Addendum 03

Date: 05-22-2026
Project: 22011 – Spin Lofts
521 21st Ave
Council Bluffs, IA

ELECTRICAL DRAWINGS

E8 TYPICAL UNIT PLAN - 1B - BED - ELECTRICAL

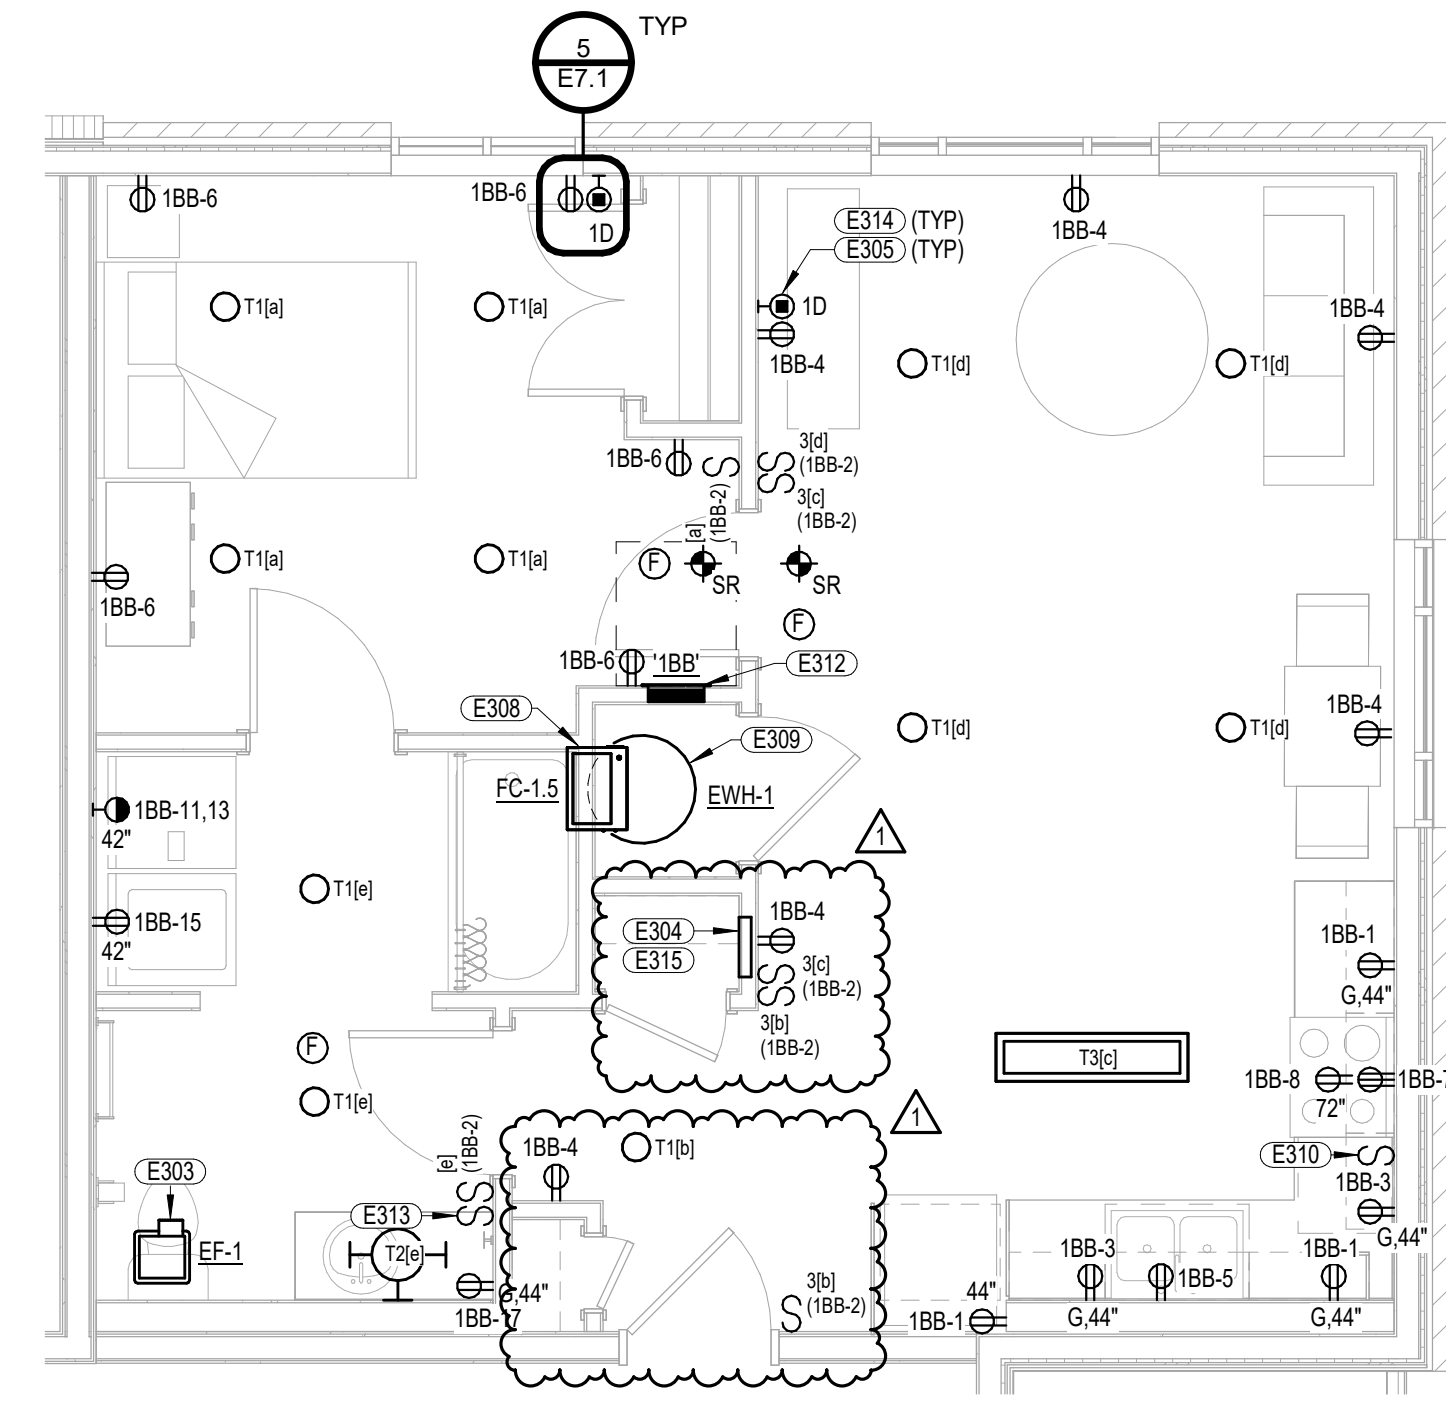
- a. At Unit Plan 1A, revise SOHO box location.
 - b. At Unit Plan 1B, revise SOHO box location and electrical outlet and switch by unit entry door.
 - c. At Unit Plan 2A, revise SOHO box location.

J9 TYPICAL UNIT PLAN - 2A.1 - 2 BED - ELECTRICAL
E3.3 SCALE: 1/4" = 1'-0"

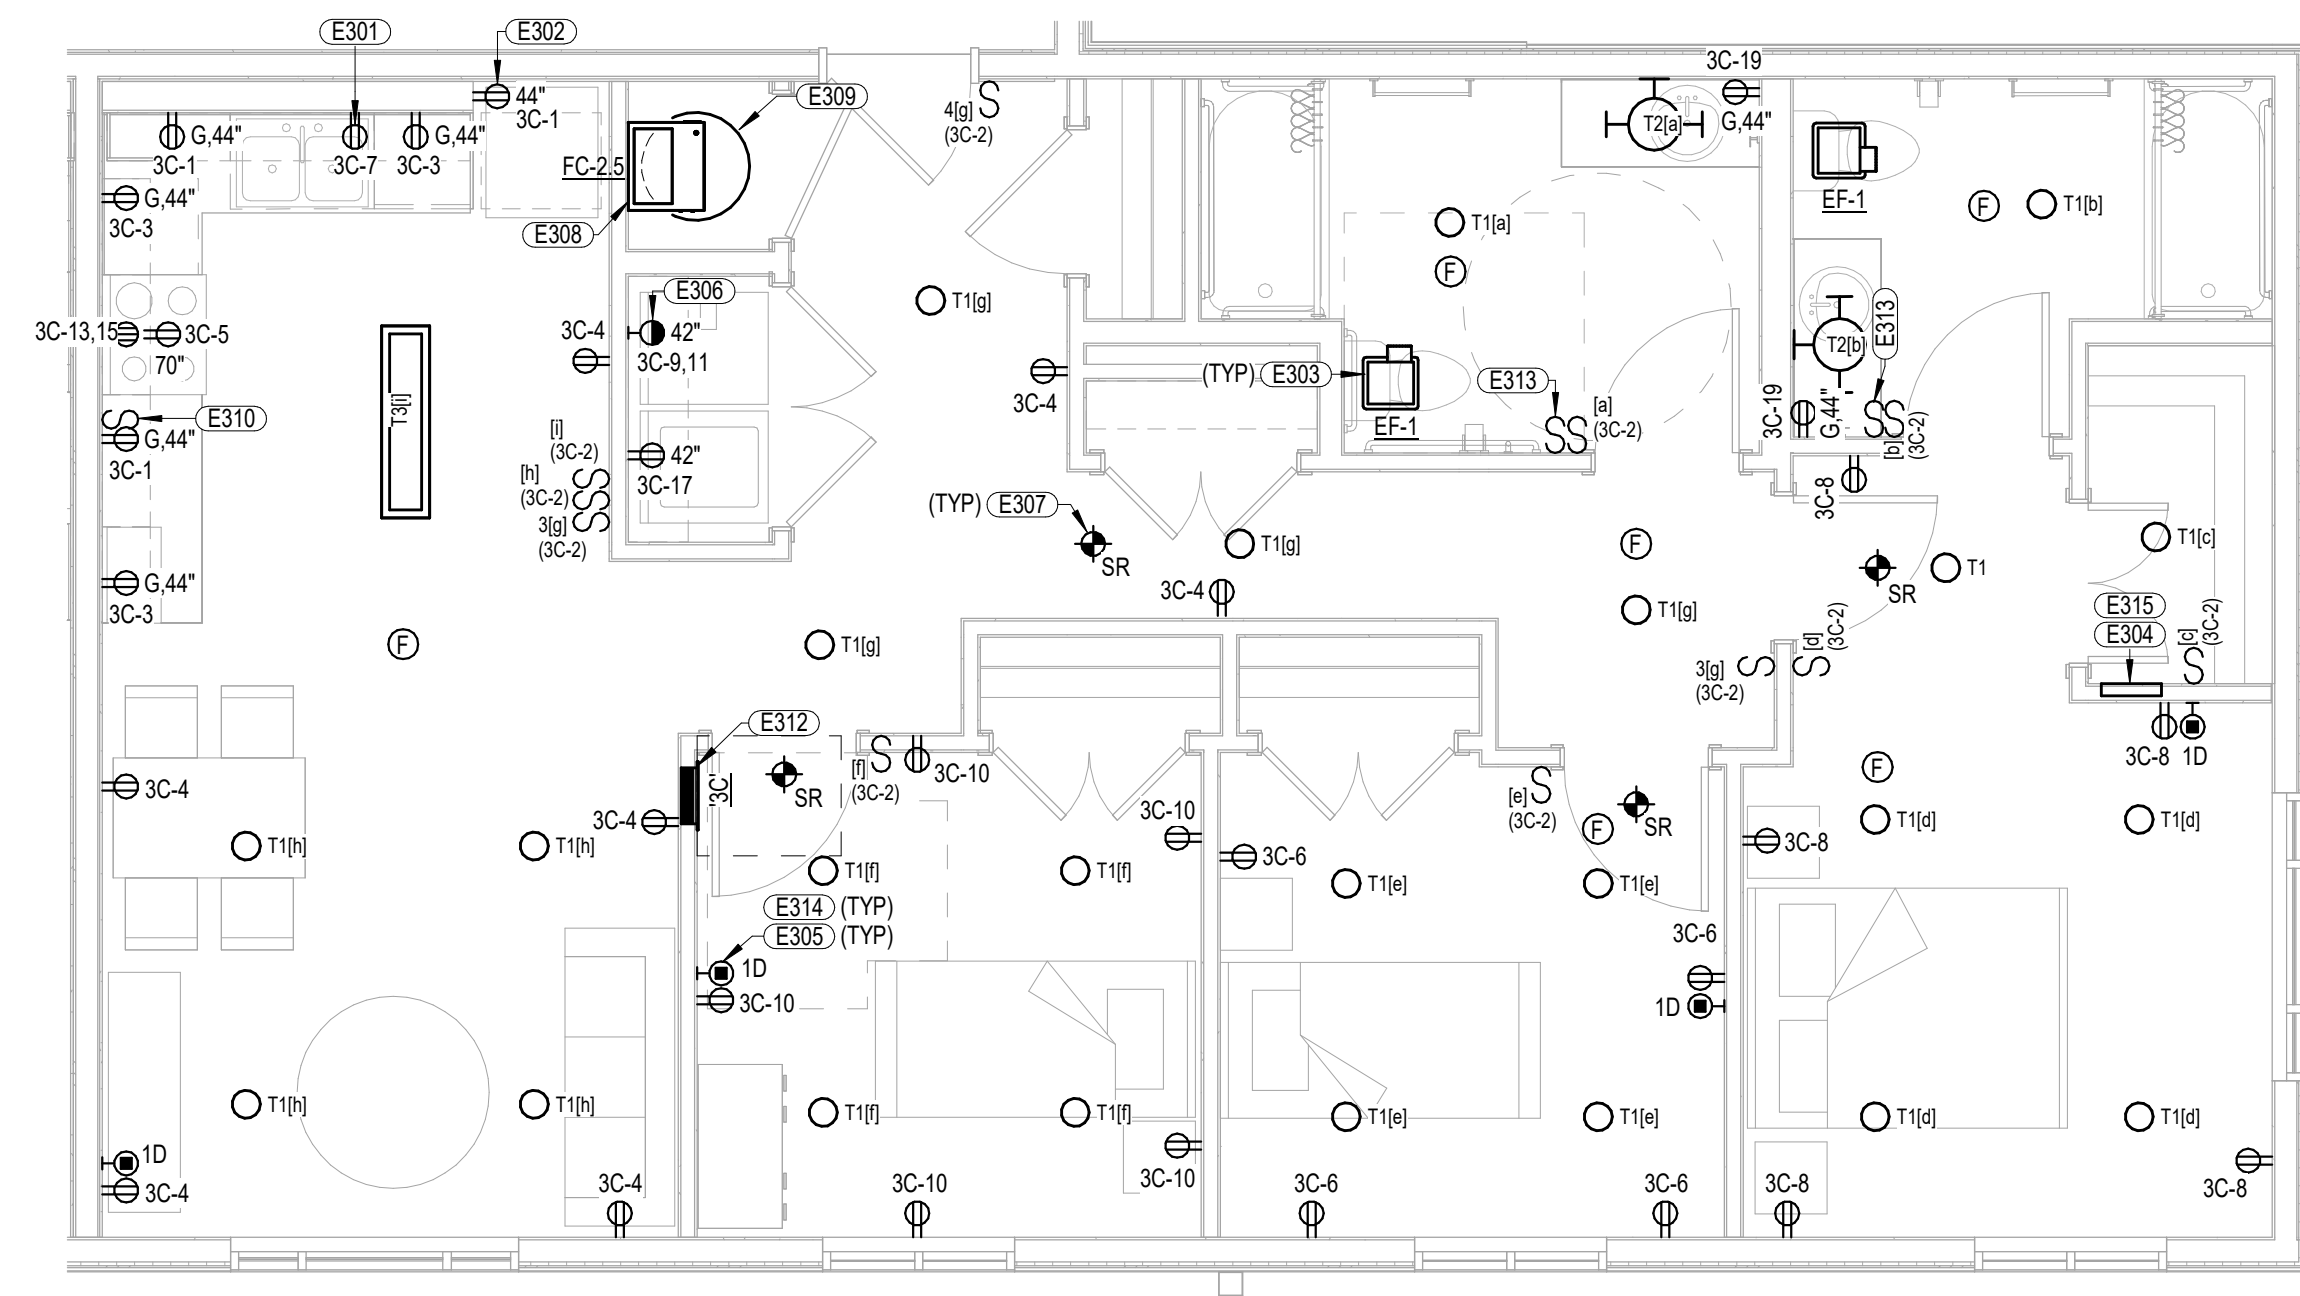
- d. At Unit Plan 2C, revise light switch by unit entry door.
5. Sheet E3.2: ENLARGED UNITS PLANS - ELECTRICAL
 - a. At Unit Plan 2A.1, revise light switch by unit entry door.
